DOCKETED	
Docket Number:	11-AFC-04
Project Title:	Rio Mesa Solar Electric
TN #:	233568
Document Title:	Applicant's Supplemental Response to Data Request 16 and 26 Additional Information Regarding Alternatives
Description:	Document was on proceeding webpage and is now moved over to the docket log.
Filer:	Marichka Haws
Organization:	California Energy Commission
Submitter Role:	Commission Staff
Submission Date:	6/19/2020 3:45:24 PM
Docketed Date:	6/19/2020

APPLICANT’S SUPPLEMENTAL RESPONSE TO DATA REQUEST 16 AND 26: ADDITIONAL INFORMATION REGARDING ALTERNATIVES

**ON-SITE ALTERNATIVE 1
 RIO MESA SOLAR
 ELECTRIC GENERATING FACILITY**

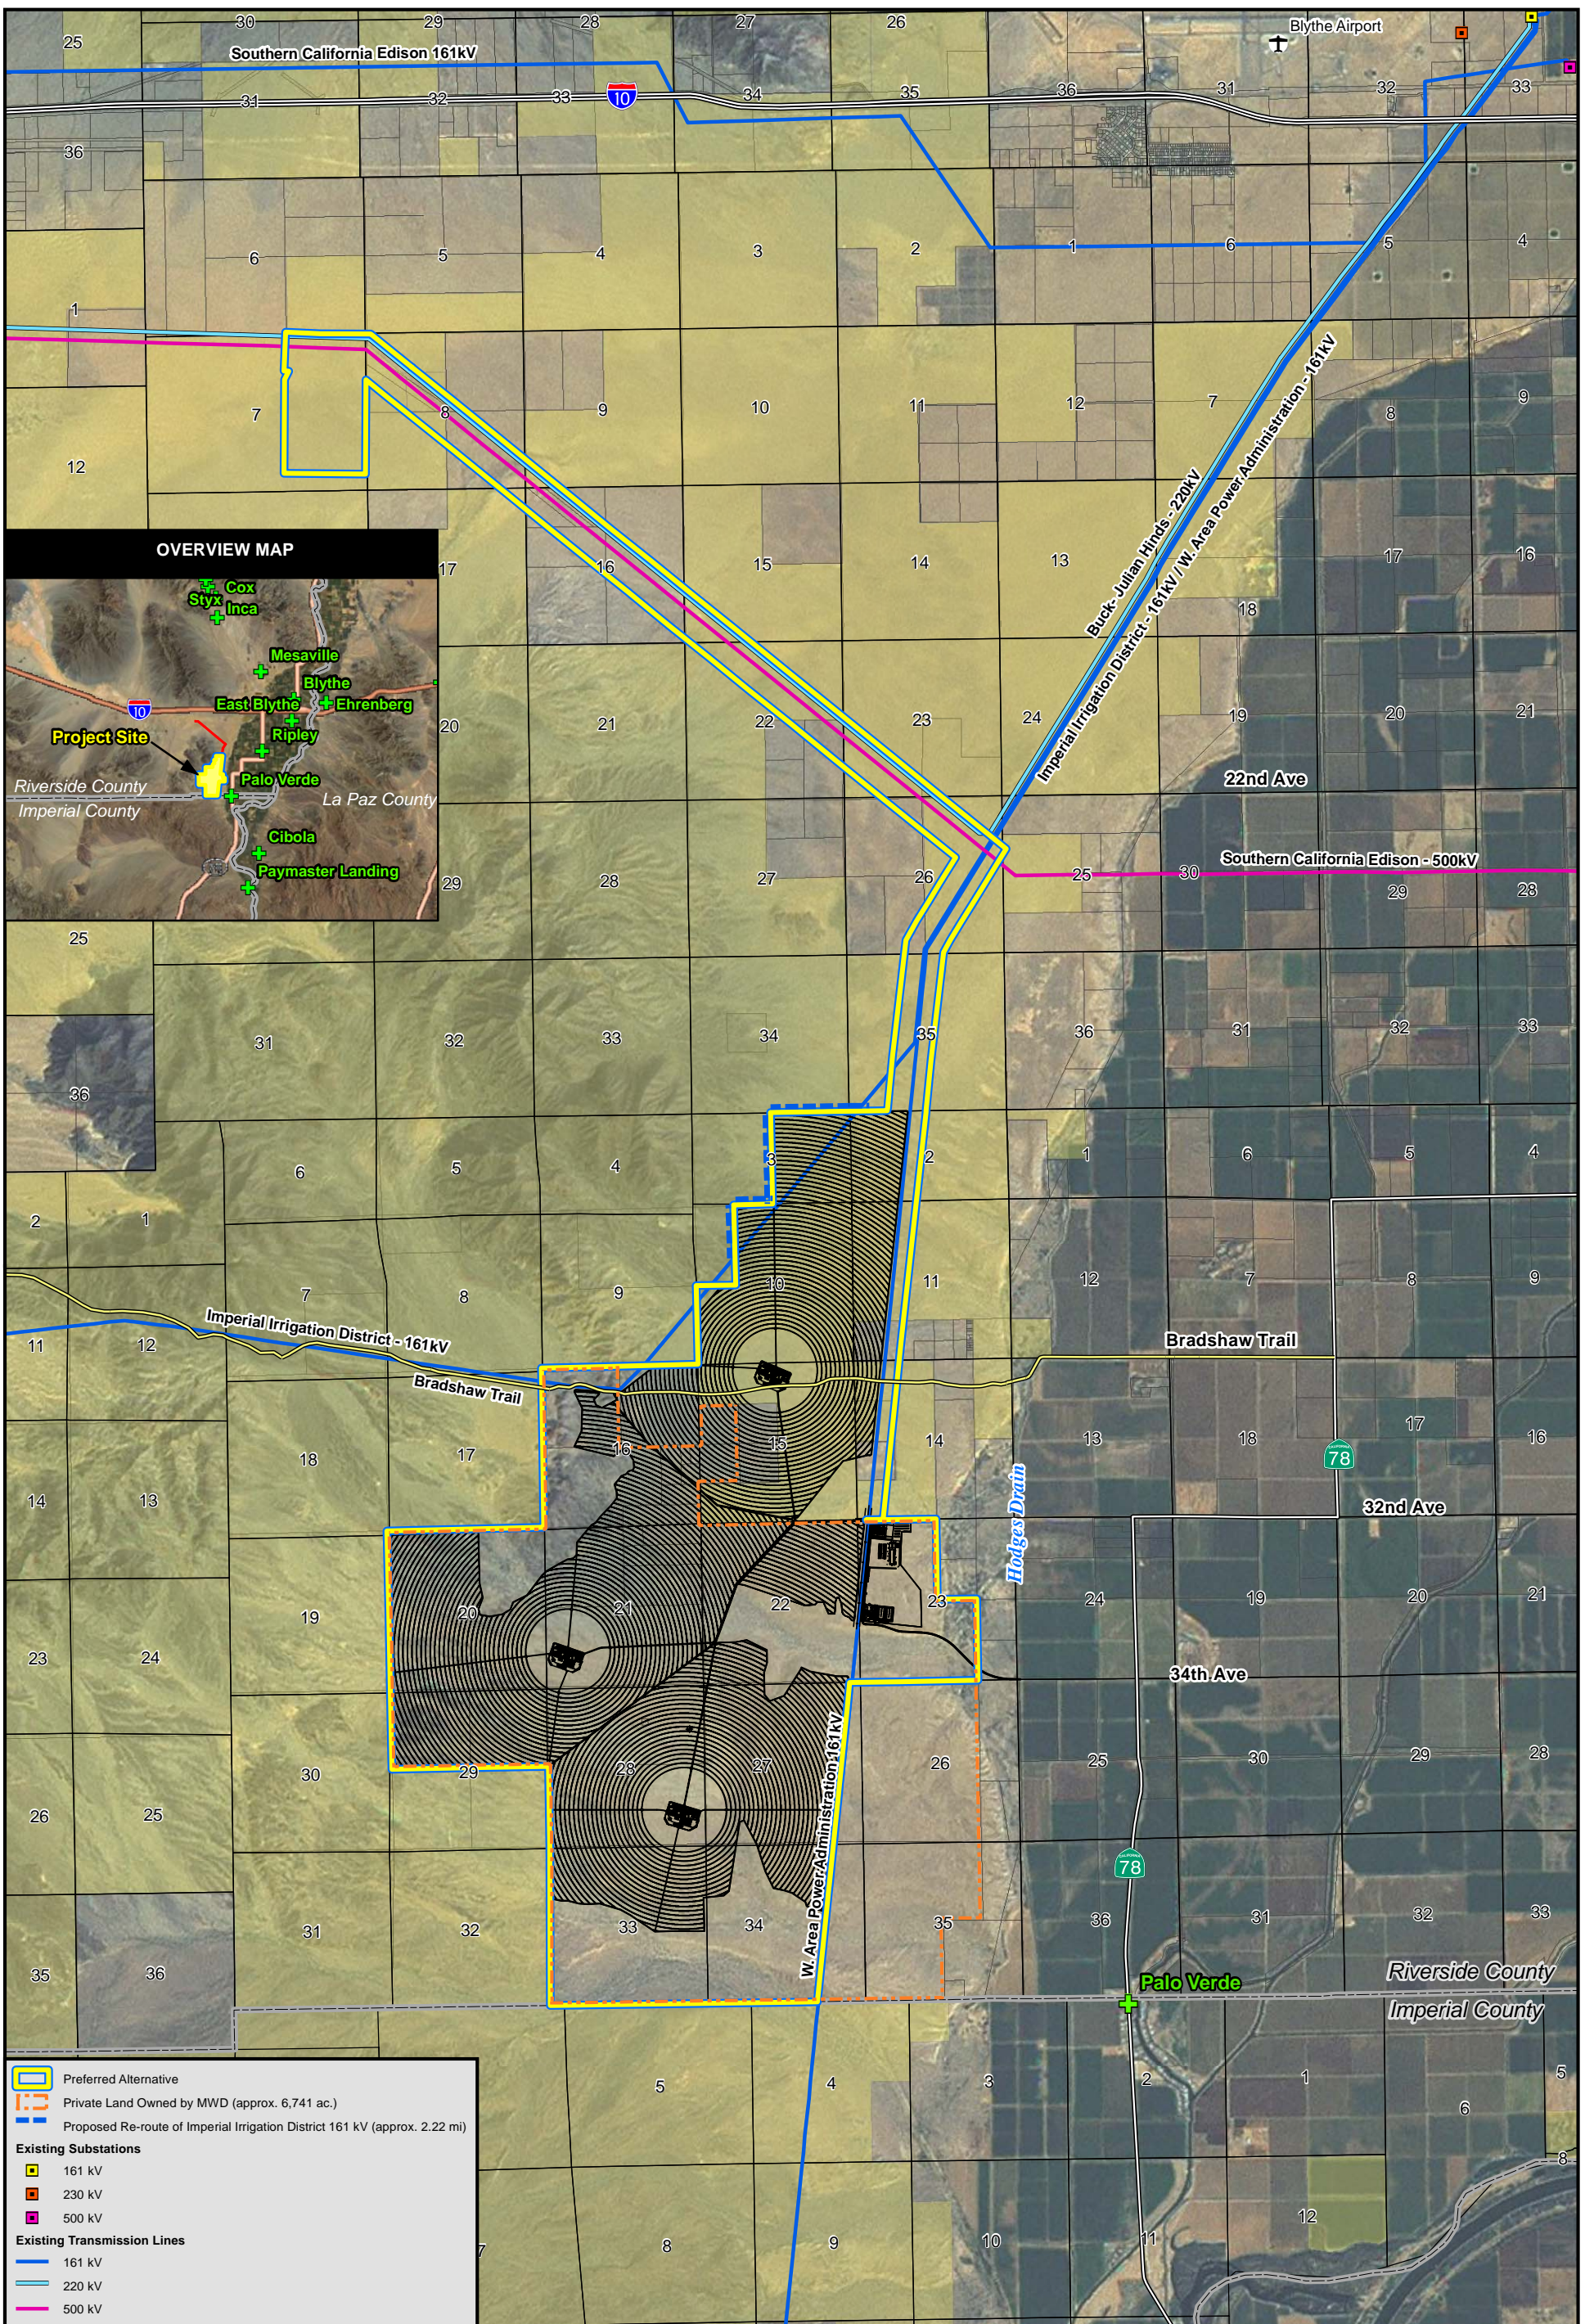
1. The [750 MW MWD and BLM Preferred](#) Alternative ~~(the Project or Rio Mesa SEGF)~~: three 250 MW plants located on a combination of MWD-owned private land and BLM-administered public land (see Figure 6.3-1).
2. The 750 MW MWD-Only Alternative: three 250 MW plants located solely on MWD-owned land, both to the east and to the west of the WAPA 161 kV transmission line (see Figure 6.3-2). and
3. The 500 MW MWD-Only Alternative [\(the Project or Rio Mesa SEGF\)](#): two 250 MW plants located solely on MWD-owned land, but only to the west of the WAPA 161 kV transmission line (see Figure 6.3-3 [\(rev\)](#)).

~~The Preferred Alternative (the Project or Rio Mesa SEGF) Alternative 1~~ consists of three 250 MW plants located on a combination of MWD-owned private land and BLM-administered public land, as shown on Figure 6.3-1. The private land portions of the project site are currently under option by the Applicant and meet all of the project objectives.

CREATED BY: DT	DATE: 7/12/2012	FIG. NO: 6.3-3	(REV)
PM: AL	PROJ. NO: 27651003.40010

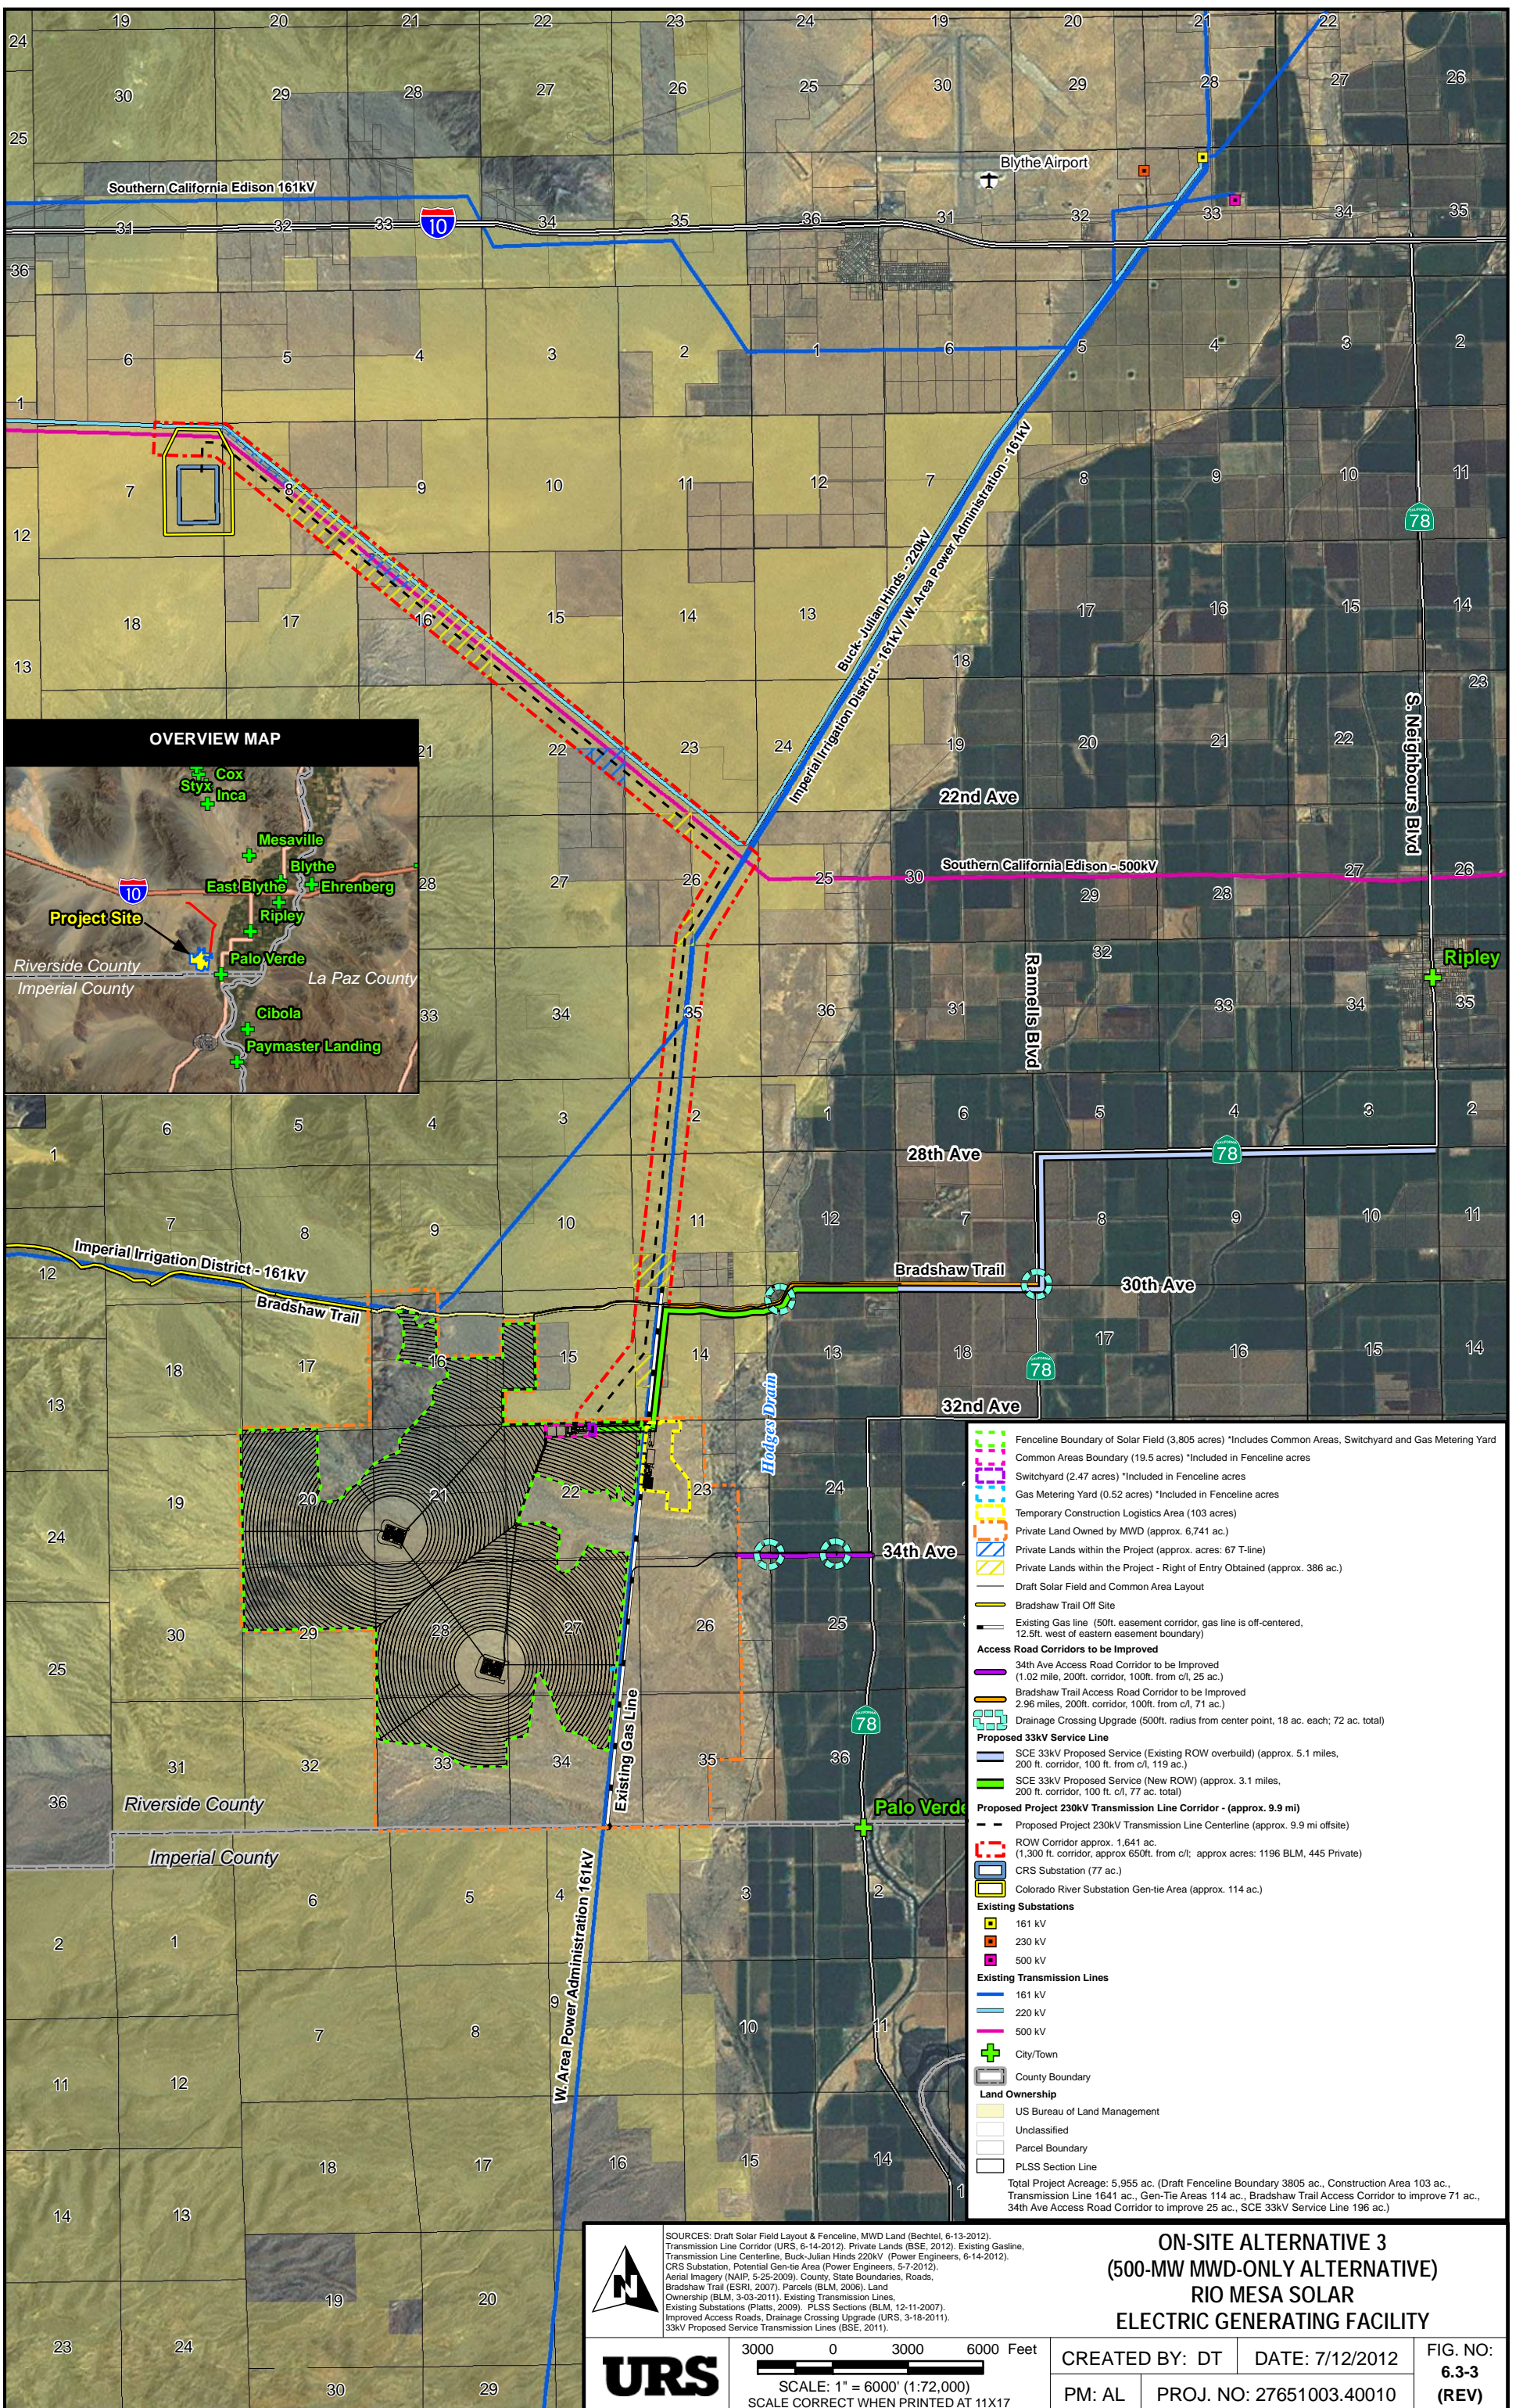
The major project features distinguishing On-Site Alternative 3 from ~~Alternative 1~~ the Preferred Alternative are summarized in Table 6.3-4 and described below. In addition, Alternative 3 is shown on Figure 6.3-3 (rev). Alternative 3 includes the features described below.

- Two 250 MW plants to be developed solely on MWD-owned land (i.e., plants will not be constructed on BLM-administered public land).
- Due to the technical infeasibility of beaming across a transmission line, and the conflicts with Project objectives associated with relocation of the WAPA 161 kV transmission line, Alternative 3 will be located on the west side of the WAPA 161 kV transmission line only.
